APPLICATION FOR PERMIT TO DRILL

2. NAME OF OPERATOR: MERRION OIL & GAS CORPORATION		7. UNIT or CA AGREEMENT NAME: N/A
3. ADDRESS OF OPERATOR: 610 REILLY AVE. CITY FARMINGTON STATE NM ZIP 87401		8. WELL NAME and NUMBER: SCUD 1
PHONE NUMBER: (505) 327-9801		9. FIELD AND POOL, OR WILDCAT: BUZZARD BENCH

**DIVISION OF OIL, GAS AND MINING
APPLICATION FOR PERMIT TO DRILL
STATEMENT OF BASIS**

ON-SITE PREDRILL EVALUATION
Division of Oil, Gas and Mining

Casing Schematic

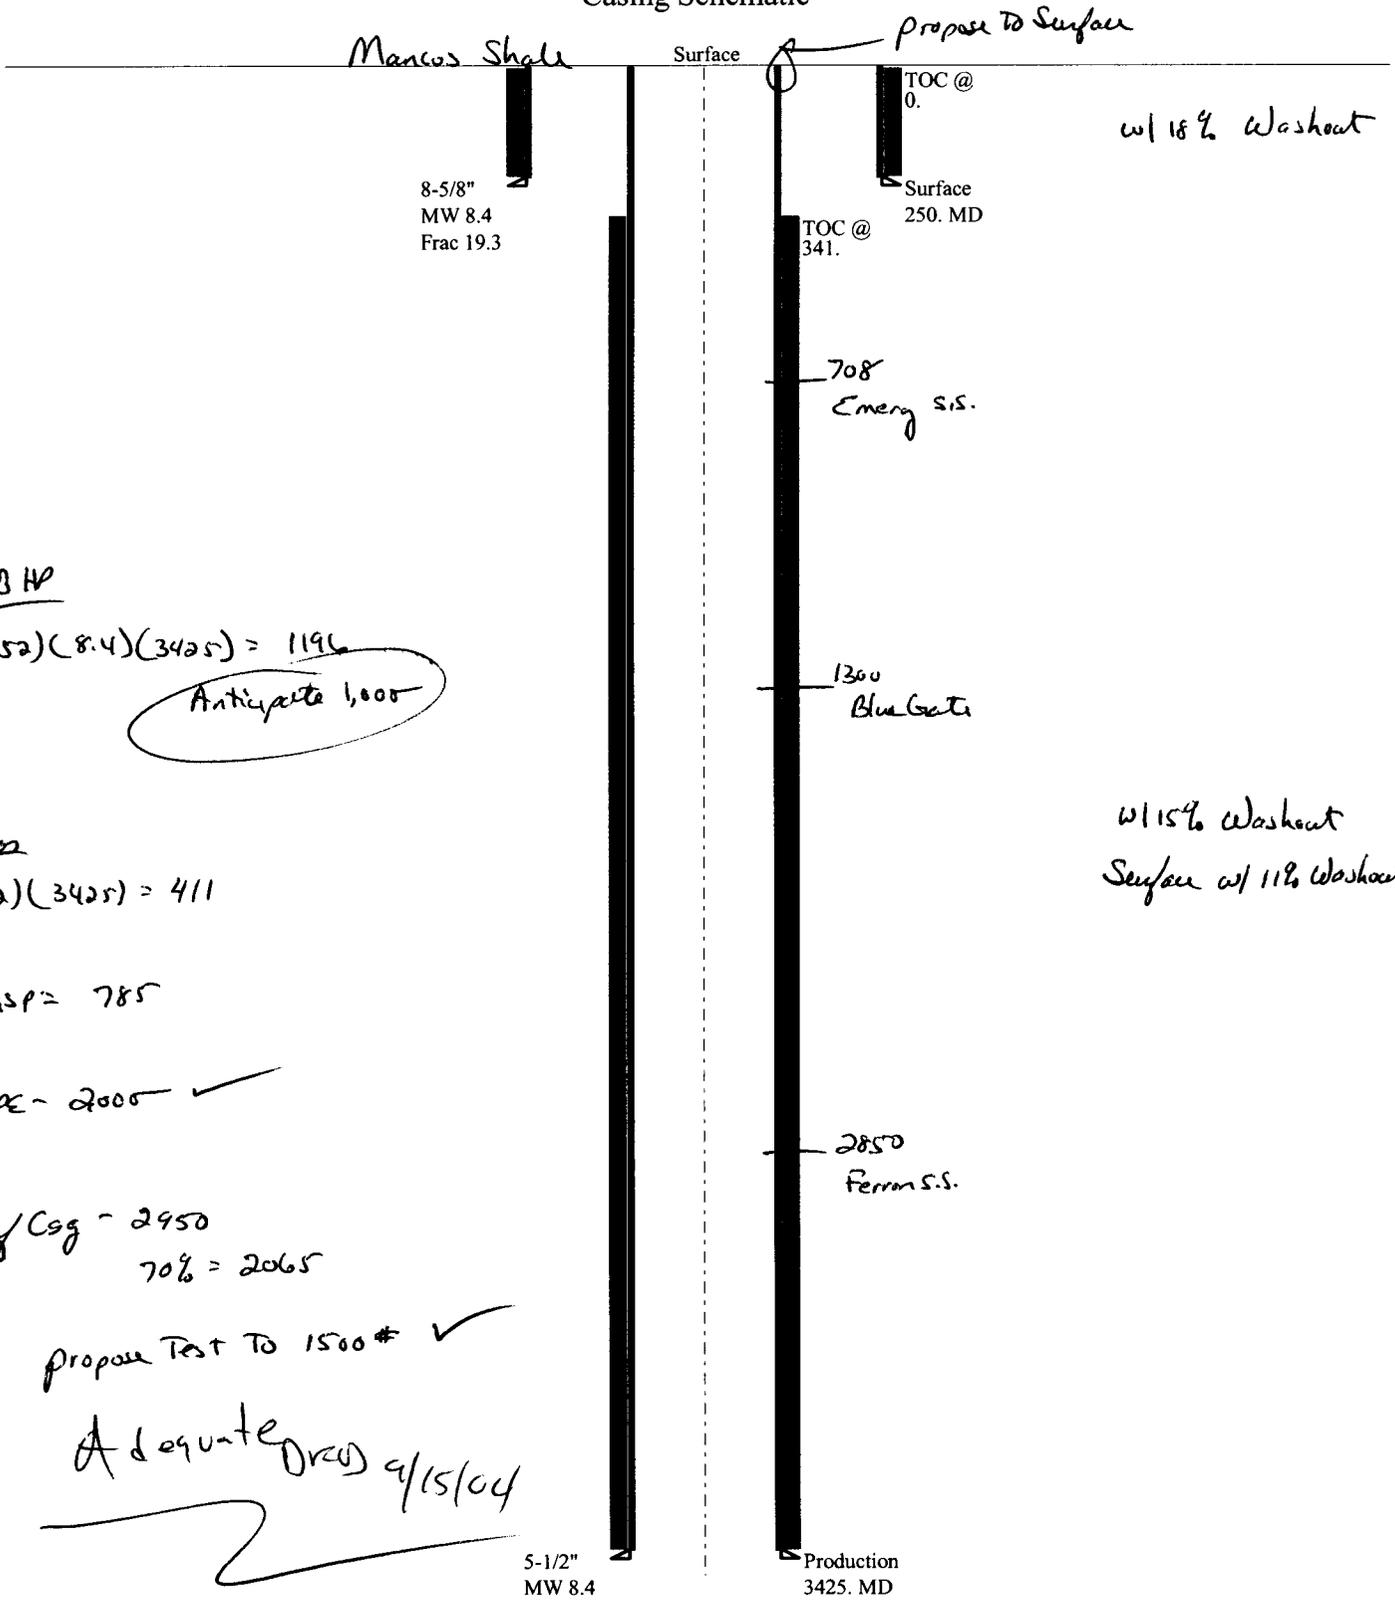
BHP
 $(.052)(8.4)(3425) = 1196$
 Anticipate 1,000

G₀₂
 $(.12)(3425) = 411$

MASP = 785

BOPE - 2000 ✓

Surf Csg - 2950
 70% = 2065

Propose Test To 1500# ✓

Adequate DRO 9/15/04
